Docket Item #3  
 BZA Case # 2025-00012  
 Board of Zoning Appeals  
 January 12, 2026

**ADDRESS:** 408 EAST MONROE AVENUE  
**ZONE:** RB, TOWNHOUSE ZONE  
**APPLICANT:** JARED AND OLIVIA GRIFFIN  
**ISSUE:** Variance to construct an accessory structure forward of a front building wall facing a primary front yard.

25.0510 - GRIFFIN RESIDENCE ADU

PROPOSED BASEMENT FLOOR PLAN

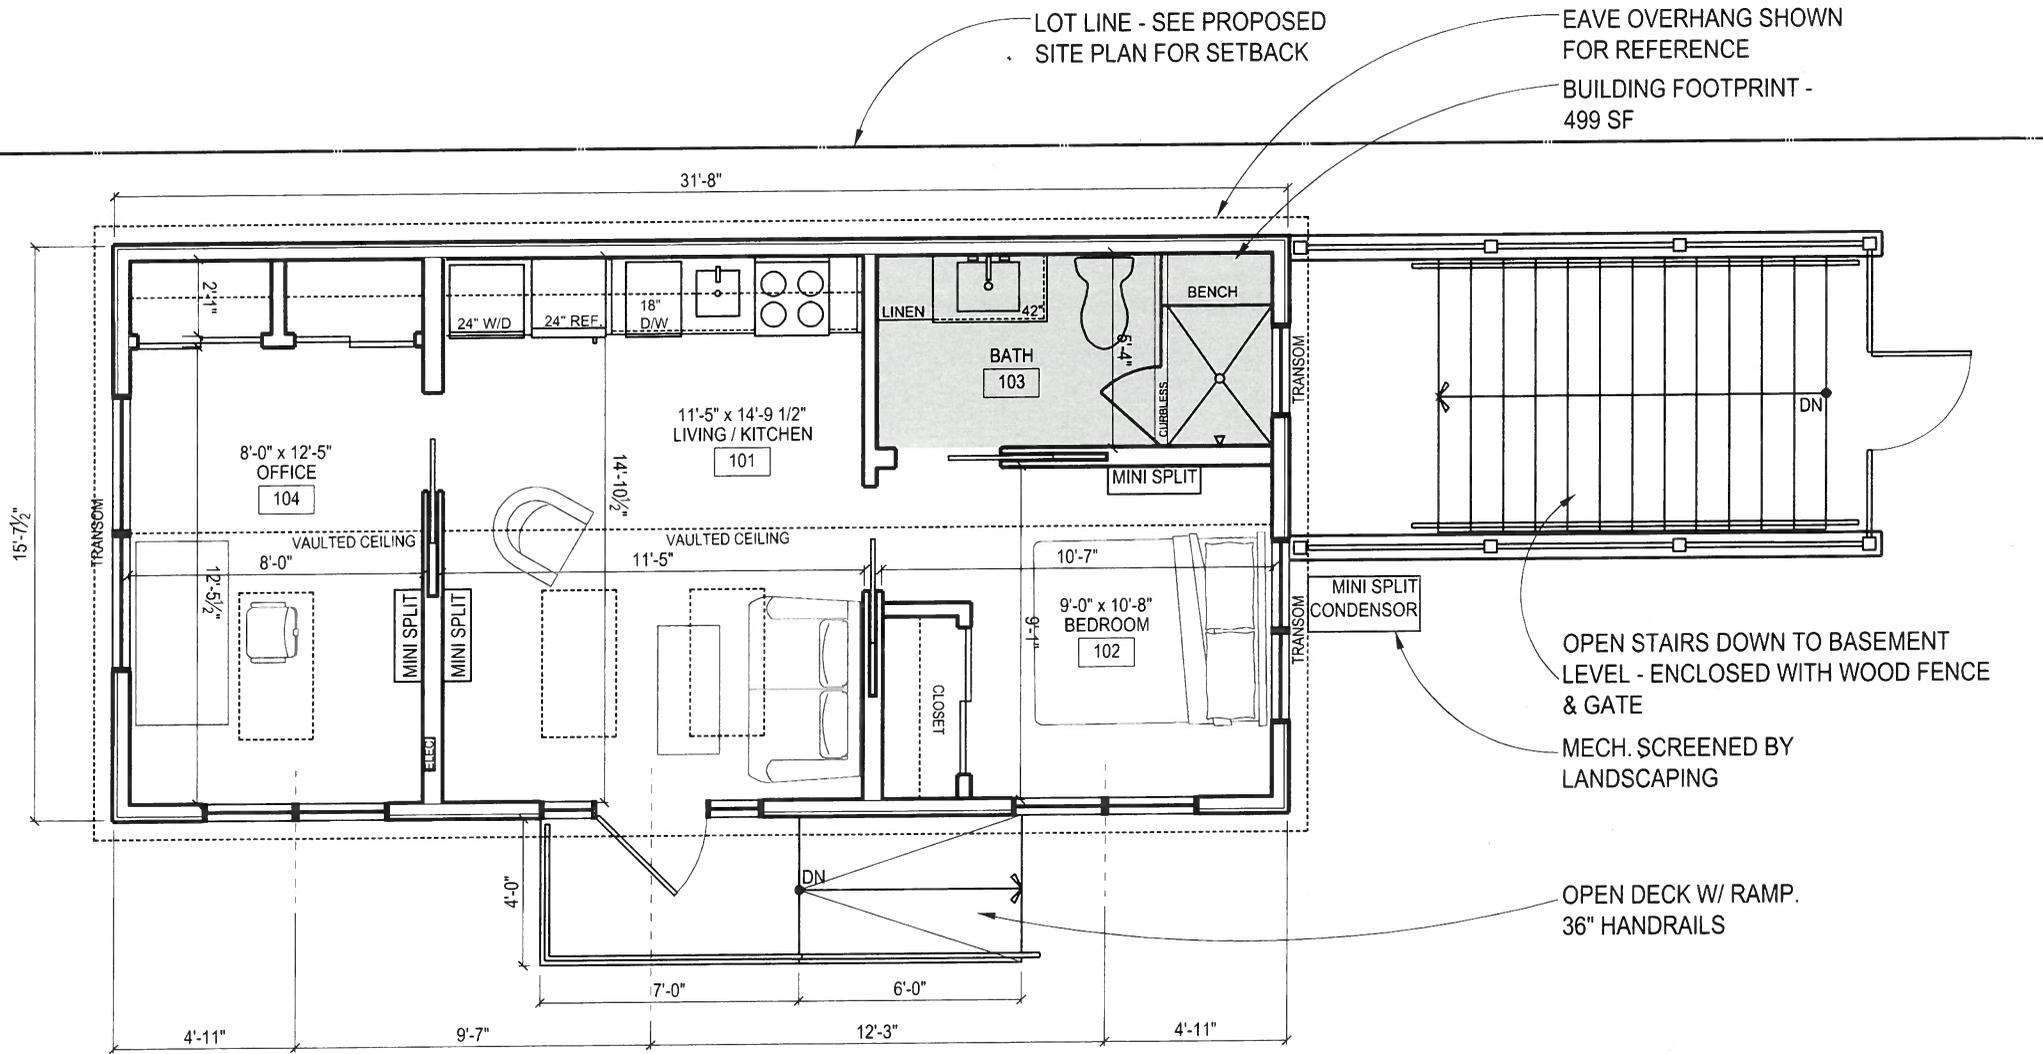
- a. The site plan drawing did not document existing trees and vegetation. The applicant shall submit a landscape plan in future submissions requiring approval.

**PROPOSED DRIVEWAY SCREENING**

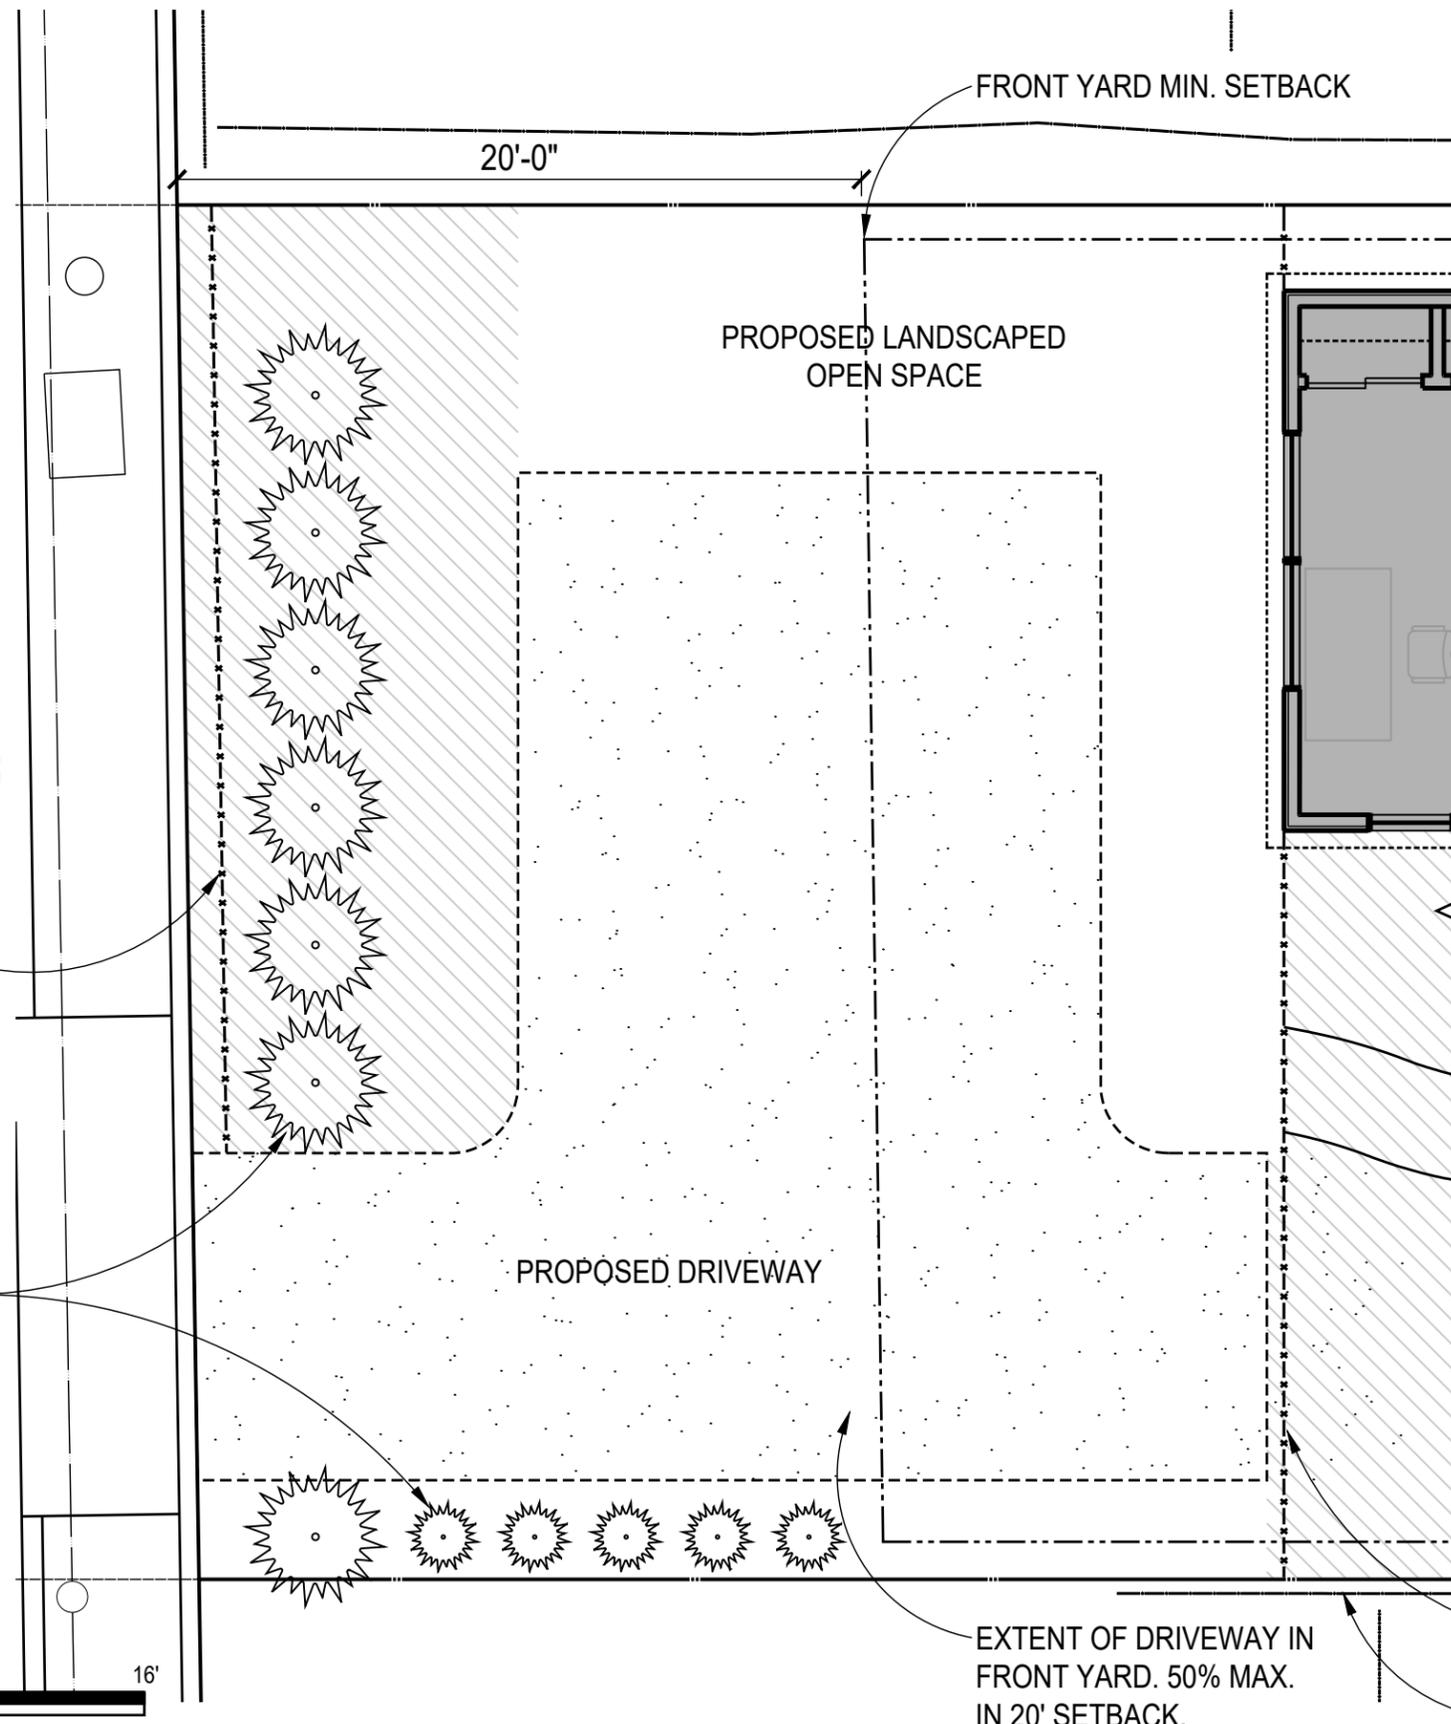
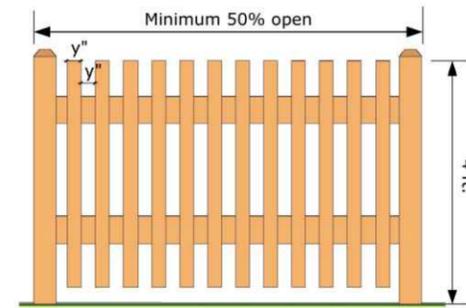
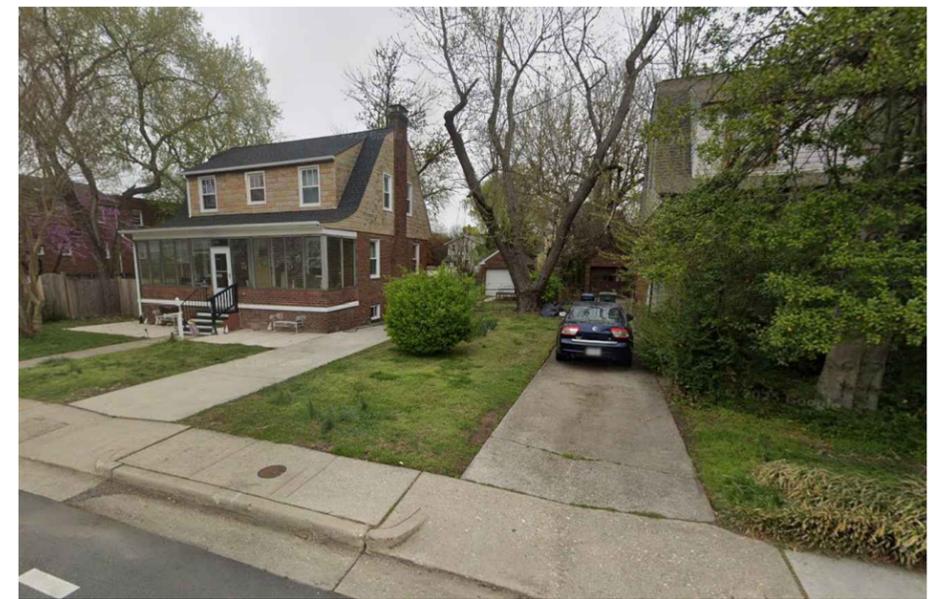
**The Land Use Committee and the Executive Board of the DRCA support a Variance for the proposed ADU, but oppose the driveway configuration as shown in the site plan.**

We are not in favor of the parking pad at the front of the ADU, and prefer to maintain a driveway only to the side of the dwelling and encourage tandem parking. Vehicles parked in front of a dwelling are not consistent with the homes along East Monroe Ave or with the majority of Del Ray. We would prefer to see the entire area in front of the ADU as landscaping rather than a parking surface. At a minimum, we have asked the applicants to install plants at the front of the lot to screen the proposed parking pad.

4' TALL FENCE W/ 50% MIN. OPEN. GRAPHIC FOR REFERENCE ONLY

LANDSCAPED AREA WITH SCREENING PLANTS

Please see the attached driveway plan document showing additional screening and landscaping on Monroe Ave in response to the Del Ray Land Use Committee's letter raising concern over the parking pad in the front yard of 408 East Monroe Avenue.

The current layout of the driveway is compliant with zoning regulations and is limited to 50% maximum of the front yard area. The additional landscaping and fencing will effectively hide the parking area and allow for a softer transition from the street. Due to the property being a single-family residence located in the RB zoning, the adjacent neighbors include apartment buildings and commercial properties that are similarly not consistent with the other homes along East Monroe. Providing a narrow, tandem length driveway creates dangerous conditions when reversing onto East Monroe, as this driveway is very close to the intersection with Dewitt Ave as well as the CVS parking lot entrance. It is much safer to allow cars to turn around on the property. The current configuration of the driveway also provides significantly more useable open space for the property than the 35% open space requirement. Reorienting the driveway into the property would reduce that open space.
